PUBLIC INTEREST REVIEW FOR GROUNDWATER APPLICATIONS

SUBJECT: Application G- 17405 Supersedes review of _____
Date of Review(s)

A. GENERAL INFORMATION: Applicant's Name: Mathew & Arlene O'Connor County: Wasco

Groundwater Application G-17405, Mathew & Arlene O'Connor Wasco County, Brown Creek Quad

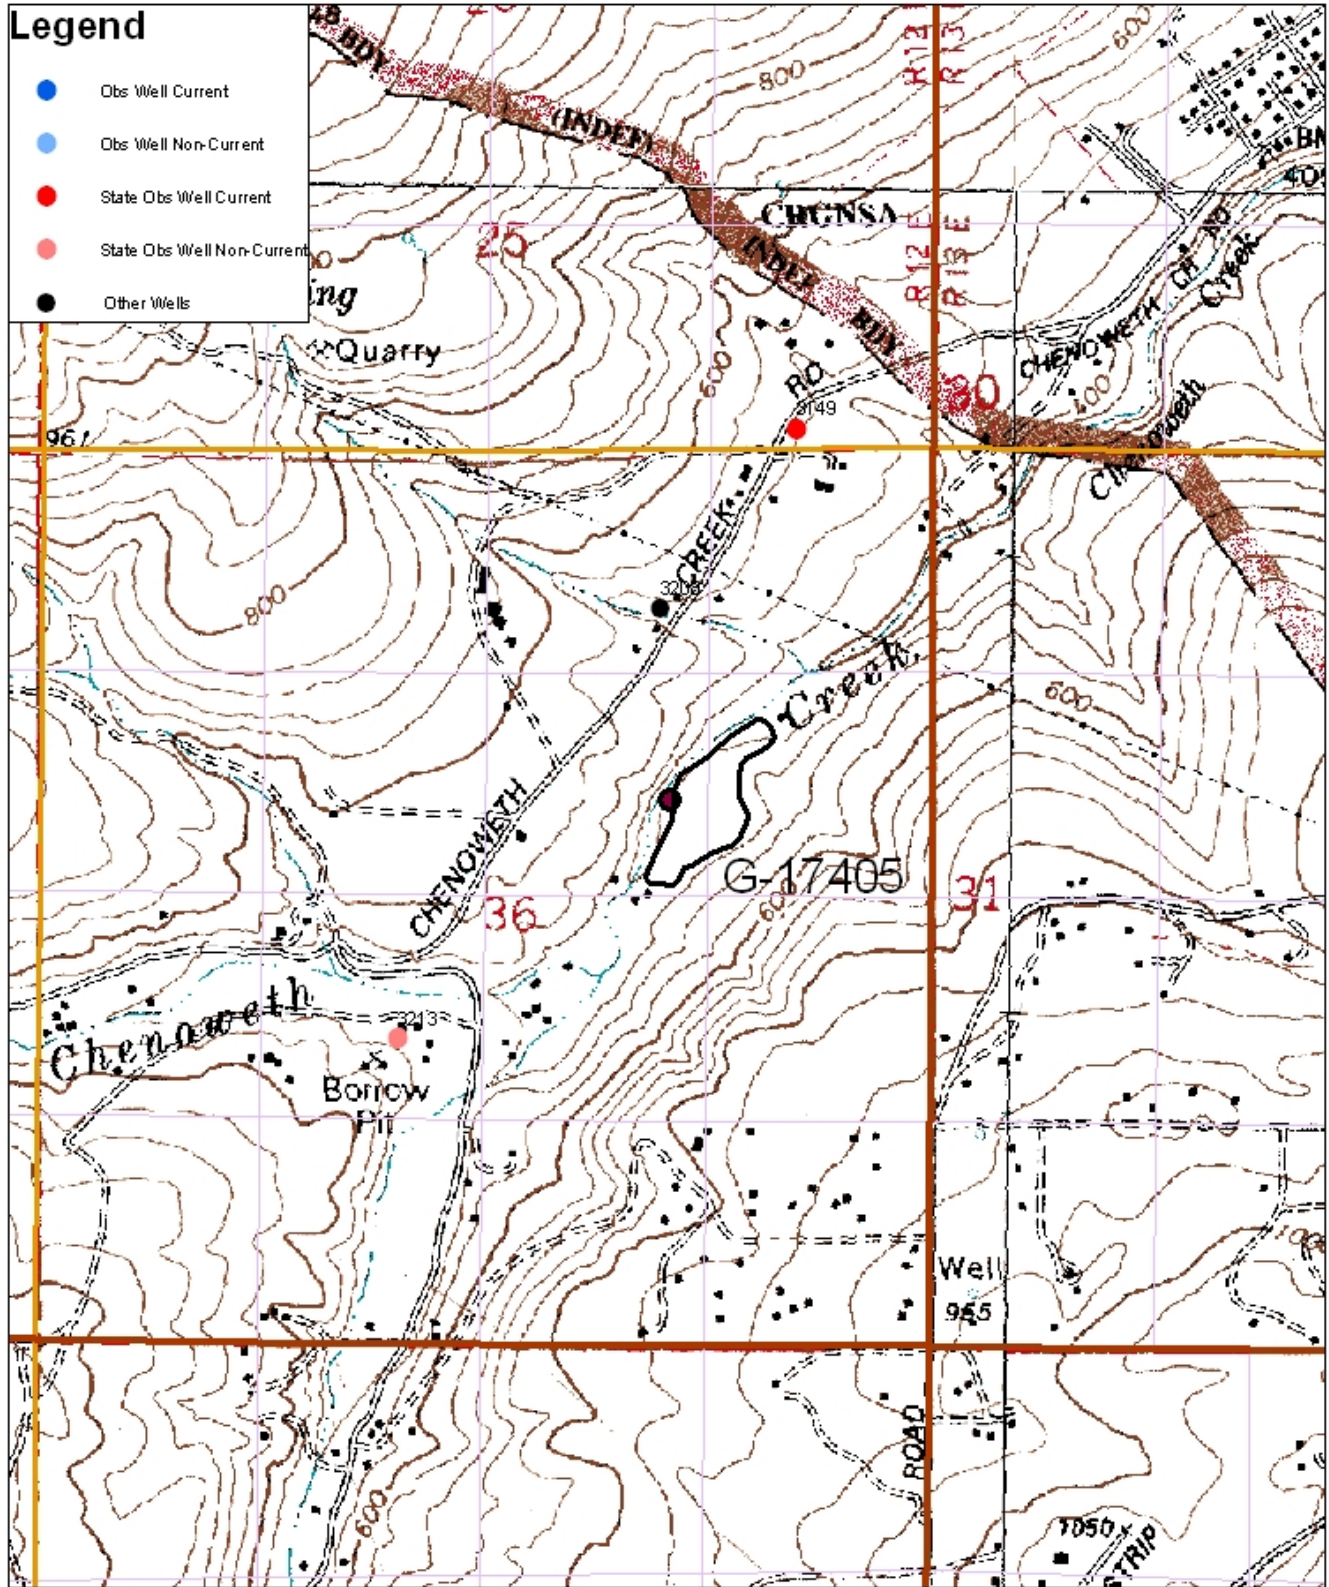
Kenny Kempf
Lithology: Sandstone
Aquifer: The Dalles Formation
Land surface elevation: 510'
Well Depth: 302'
